**ITEM SPECIAL - NOISE BARRIERS**

PROJECT ID  
117607

SHEET TOTAL  
P.197 | P.276

STEP DETAIL  
81" BARRIERS 8, 10, 12

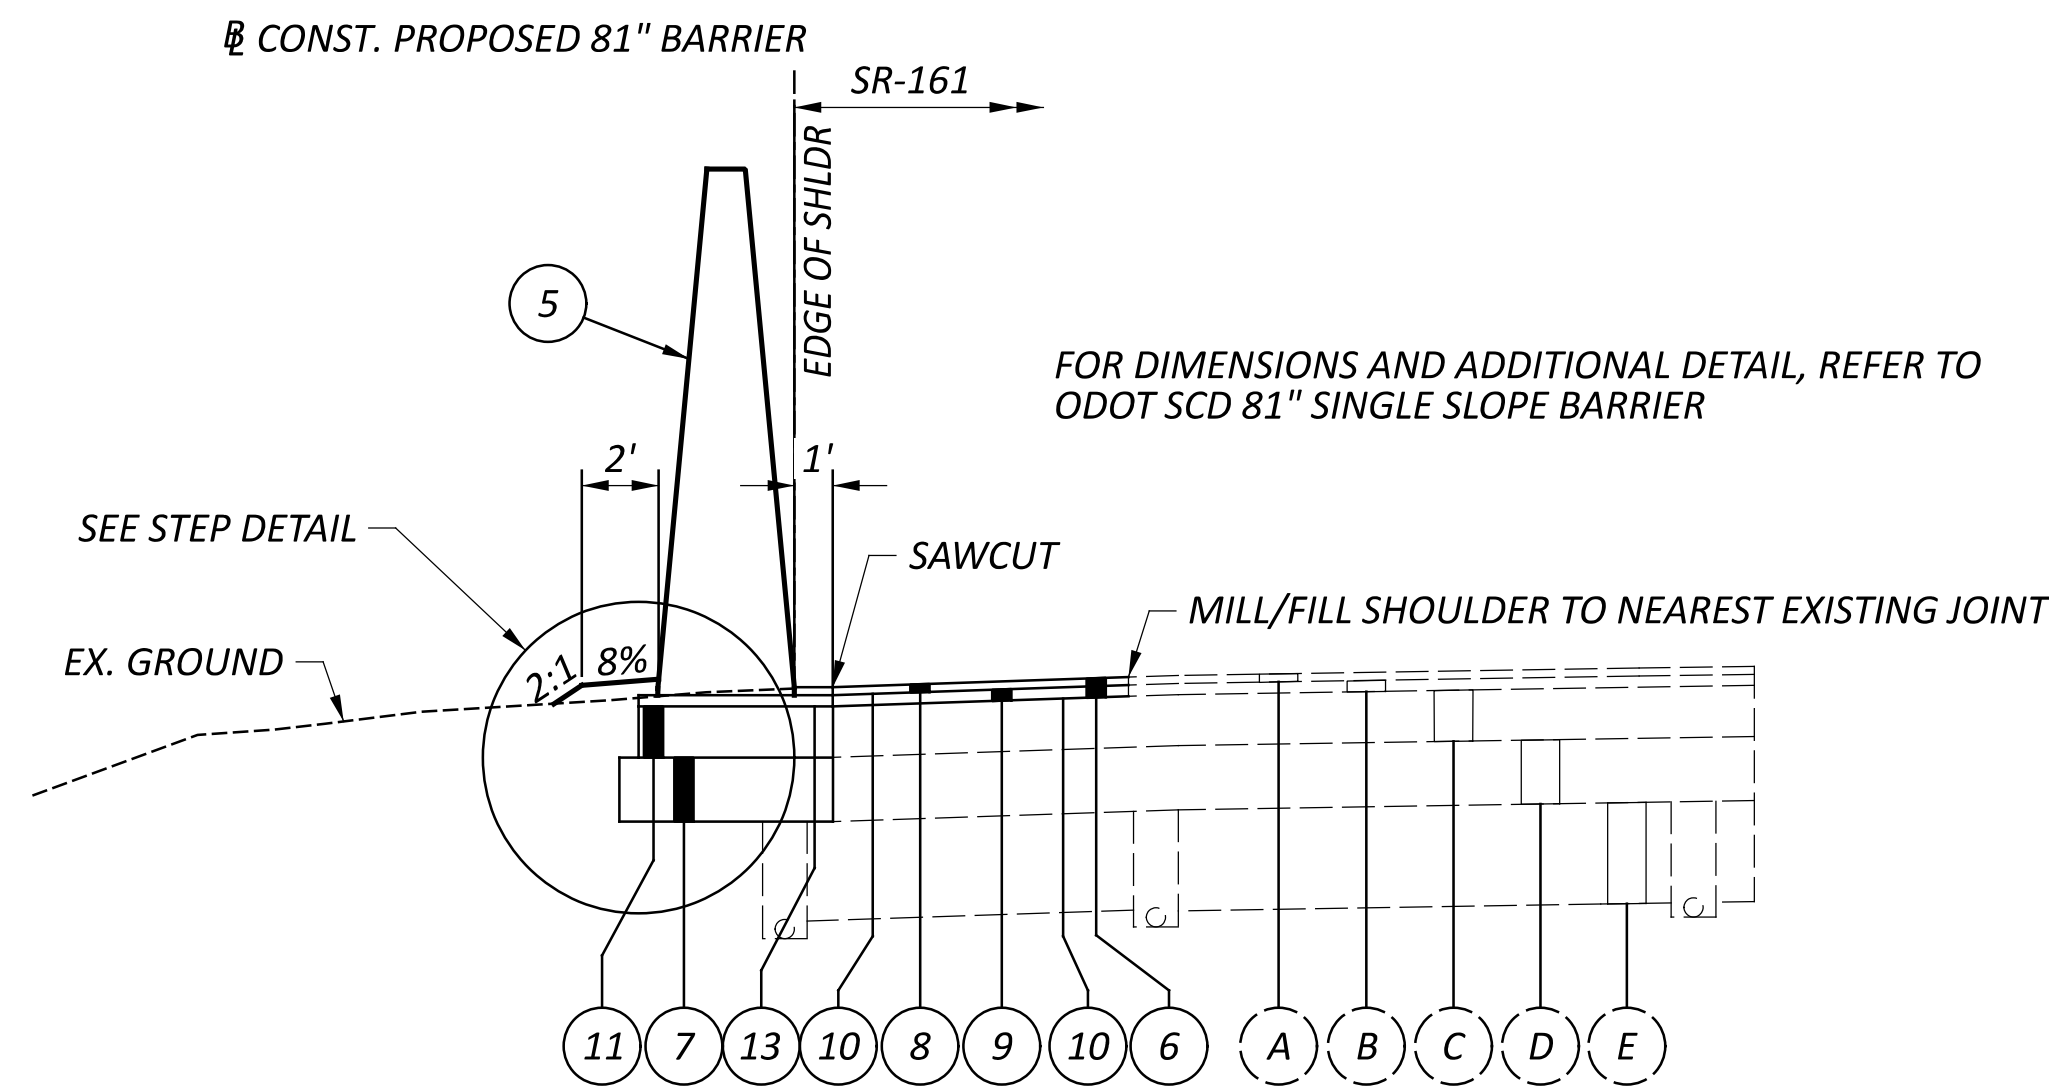
It should be noted that as part of the FRA-161-16.75/LIC-161-0.00 project from 1993, sections of SR161 were originally constructed with a 4" asphalt treated free-draining base layer that outlet through underdrains that daylight along the embankment. The City of Columbus, Department of Public Service, Street Maintenance performs bi-annually inspections and makes sure that they are clear of debris. It is critical that these outlets are considered during design of this project and are not disturbed during construction and remain clear. Additionally, future access to the outlets for maintenance purposes should remain. Mapping of their locations used by Street Maintenance will be provided.

ARCADIS RESPONSE - AFTER REVIEW OF THE UNDERDRAIN OUTLETS THROUGHOUT THE PROJECT CONSTRUCTION LIMITS, TWO LOCATIONS APPEAR TO BE IN CONFLICT: (BARRIER 6, STA. 5999+90 - OUTLET #101050) AND (BARRIER 12, STA. 1207+40 - OUTLET # UNKNOWN). AT BOTH LOCATIONS ARCADIS HAS PROVIDED PLAN NOTES AND/OR DETAILS TO REMEDY THE CONFLICT. PLEASE REFER TO PAGES 36 AND 76 REGARDING THE CONFLICT AT 5999+90 AND PAGE 56 REGARDING THE CONFLICT AT STA 1215+22.

ARCADIS RESPONSE - A NOTE HAS BEEN ADDED TO TYPICAL SECTION SHEET 6 INSTRUCTING THE CONTRACTOR TO CAUTIONING THE CONTRACTOR TO NOT DISTURB EXISTING UNDERDRAINS AND ENSURE OUTLETS ARE MAINTAINED.
